PERMIT # OSWP-2022-1925

SEPTIC: IMPROVEMENT PERMIT / AUTHORIZATION TO CONSTRUCT / OPERATION PERMIT / EXISTING SYSTEM

Salem Springs Subdivision Lot 36 Septic Site Plan

Project Name: Helmsman Homes Salem Springs Lot 36

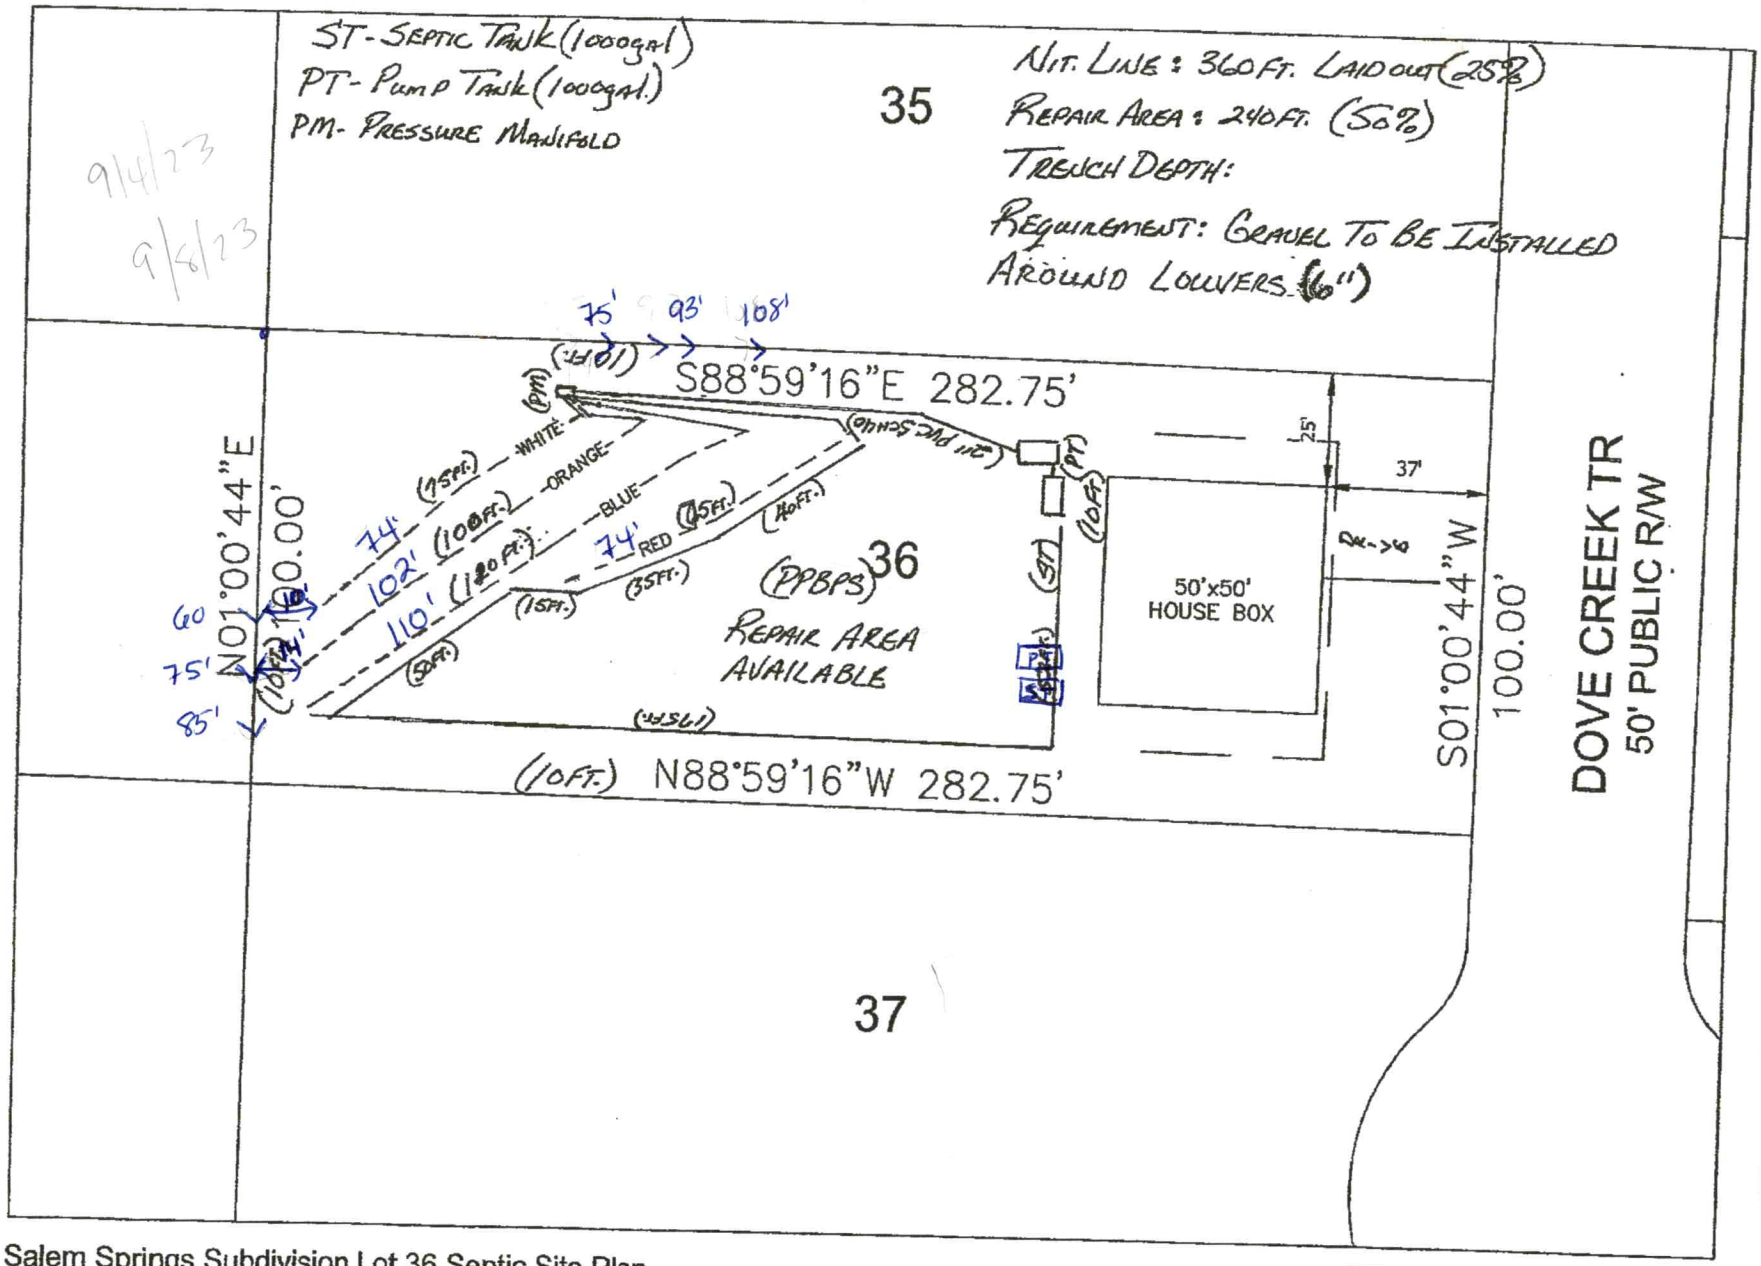
See as built changes in blue on attached site plan

Some lines flagged longer in the field, shorten to lengths shown here.

Salem Springs Subdivision Lot 36 Septic Site Plan

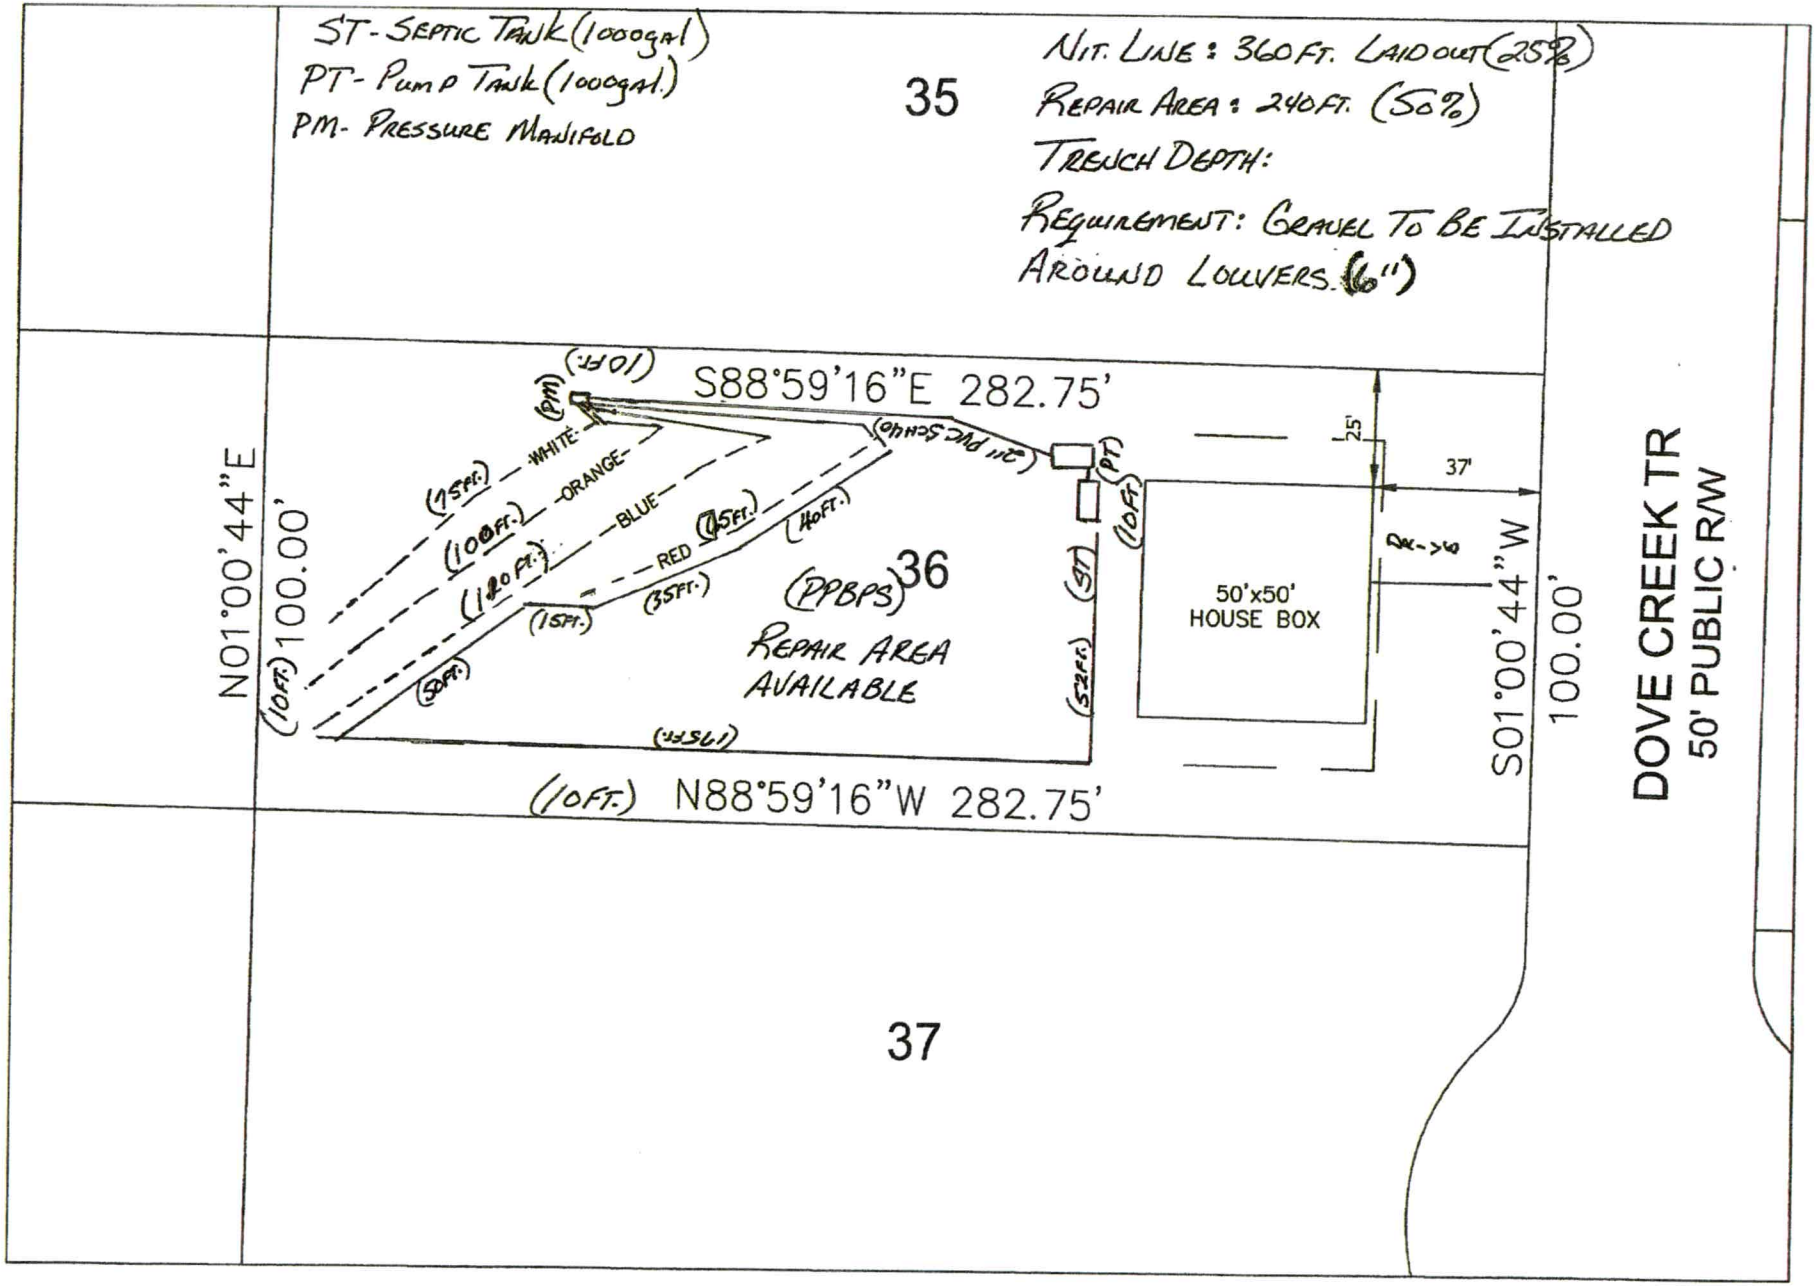
Some lines flagged longer in the field, shorten to lengths shown here.
